DEVIATION REQUEST AND DECISION FORM

Project Name :	GRANDVIEW PHASE 2 (PUDSP-23-006)
Schedule No.(s) :	4200000475, 4200000474
Legal Description :	A TRACT OF LAND BEING A PORTION SECTION 21, AND A PORTION OF THE NORTHEAST QUARTER OF SECTION 28, TOWNSHIP 12 SOUTH, RANGE 64 WEST OF THE 6TH/ PRINCIPAL MERIDIAN, EL PASO COUNTY, COLORADO

A deviation from the standards of or in Section **2.3.8.A** of the Engineering Criteria Manual (ECM) is requested.

Figure 2-13. Typical Urban Minor Arterial Cross Section

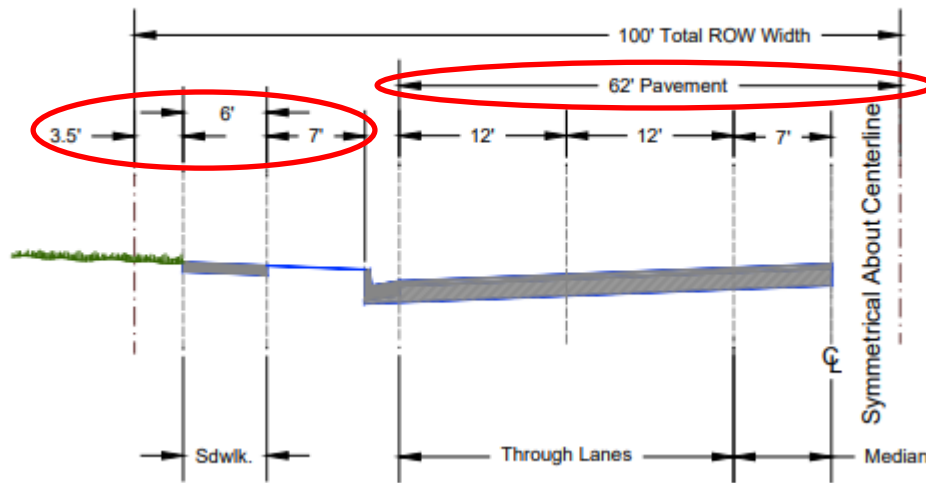
Please revise, this is the incorrect figure

Please revise, this is the incorrect figure
